AMENDMENTS TO THE DRAWINGS

REMARKS

FIG. 1 OF GOODLOE

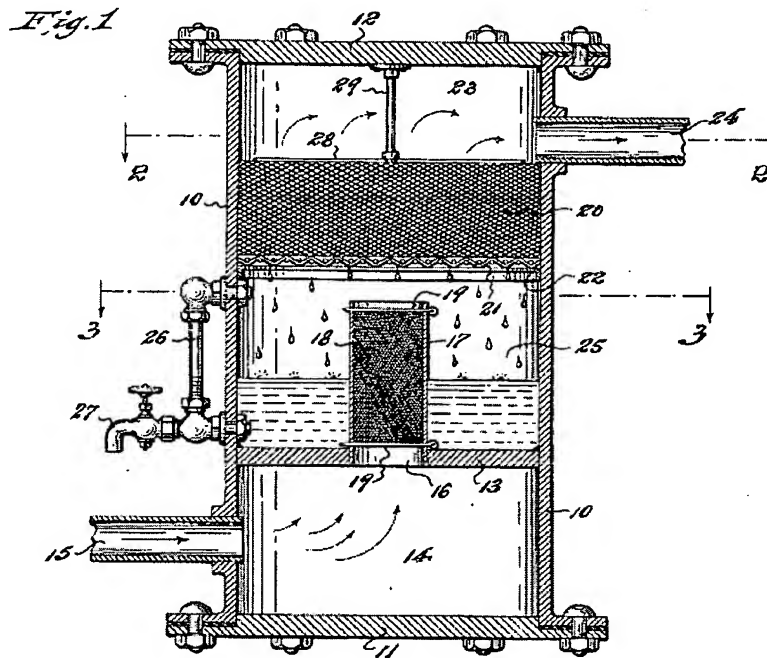
Referring to the annular well 25 shown in Fig. 1 of Goodloe (reproduced below), the rejection states that Goodloe teaches “...collecting means (25) for collecting in or downstream the agglomerating unit the liquid droplets which have broken through the agglomerating unit, and recycling

means for recycling the collected liquid from the collecting means to the lower compartment." Action, p. 5.

However, Goodloe teaches that,

The space within the interior of the casing 10 intermediate the partition wall 13 and the secondary separator mass 20, and around the upstanding housing member 17 which contains the primary separator mass 18, provides an annular well or sump 25 into which liquid, coalesced into drops by the separator masses, may fall by gravity and accumulate. Mounted on the exterior of the casing 10 so as to communicate with the interior of the well or sump 25 is a liquid level gauge 26, which is operative to indicate the depth of liquid which has accumulated in said well or sump. Coupled in connection with the lower end of said gauge 26 is a faucet or tap 27 through which the accumulated liquid may be drawn off from said well or sump when necessary.

Thus, the liquid collected by the annular well 25 from the primary separator mass 17 is removed from the casing 10 by the tap 27, not recycled from the well 25 to a lower compartment of the casing 10.

Furthermore, because the liquid collected by the annular well 25 is removed from the casing 10 by the tap 27, there is no motivation to include a “recycling means for recycling the collected liquid from the collecting means to the lower compartment” as recited in claim 1 in the device taught by Goodloe.

FIG. 1 OF McEWAN

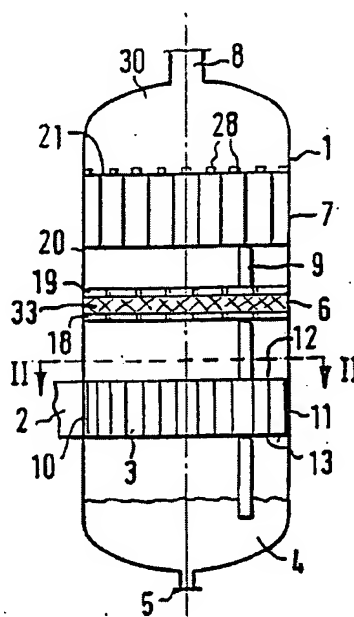
Referring to the lower part 4 of the column 1 shown in Fig. 1 of McEwan (reproduced below), the rejection states that McEwan teaches “...collecting means (4) for collecting in or downstream the agglomerating unit the liquid droplets which have broken through the agglomerating unit, and recycling means for recycling the collected liquid from the collecting means to the lower compartment.” Action, p. 6.

However, McEwan teaches that “[a]t relatively low gas velocities the coalescer removes all liquid from the gas—the liquid showers down out of the coalescer and is discharged from the bottom of the column.” McEwan, col. 2, ll. 59-62.

Thus, similar to Goodloe, the liquid collected by the lower part 4 from the coalescer 6 is removed from the column 1 by the liquid outlet 5, not recycled from the part 4 to a lower compartment of the column 1.

Furthermore, because the liquid collected by the lower part 4 is removed from the column 1 by the liquid outlet 5, there is no motivation to include a “recycling means for recycling the collected liquid from the collecting means to the lower compartment” as recited in claim 1 in the column taught by McEwan.
